# UNITED STATES PATENT AND TRADEMARK OFFICE

APPLICATION NO.	FILING DATE	FIRST NAMED INVENTOR	ATTORNEY DOCKET NO.	CONFIRMATION NO.
10/810,914	03/26/2004	Paul William Richardson	1926-00096	9412

This is the first Office Action for application number 10/810,914 Camera Mount, filed on 3/26/04. Claims 1-12 are pending.

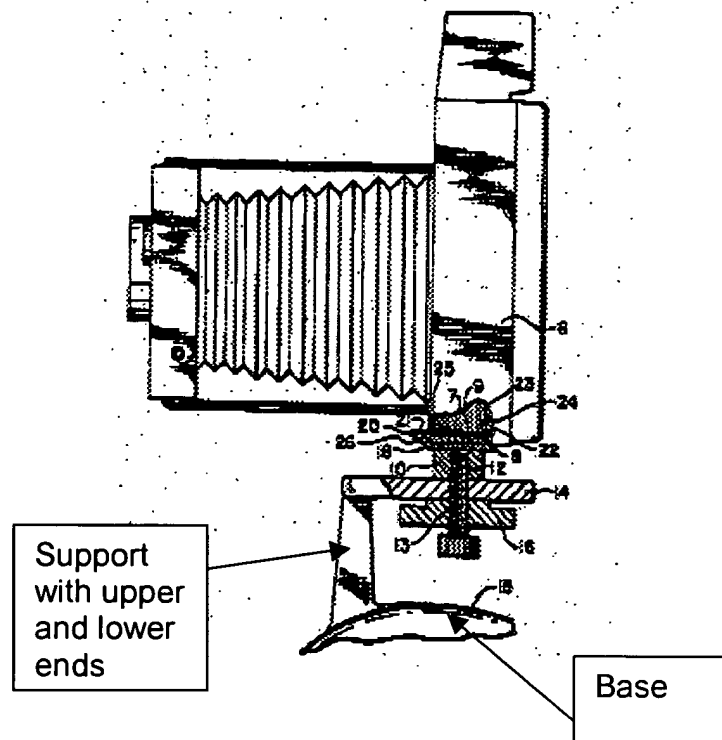
Henning discloses applicant's basic inventive concept including a camera mount having a planar surface (14) which could carry advertising or information, the camera mount having a base (15), and a substantially rigid column support (See Drawing Below) upstanding from the base (15) and having upper and lower ends, the lower end being attached to the base (15). Henning also shows that at the upper end of the support, a camera platform (8) is adjustable about a vertical axis and has a camera

mounting surface. Henning also shows that a rotatable standard camera mount screw (13) is projecting from the camera mounting surface.
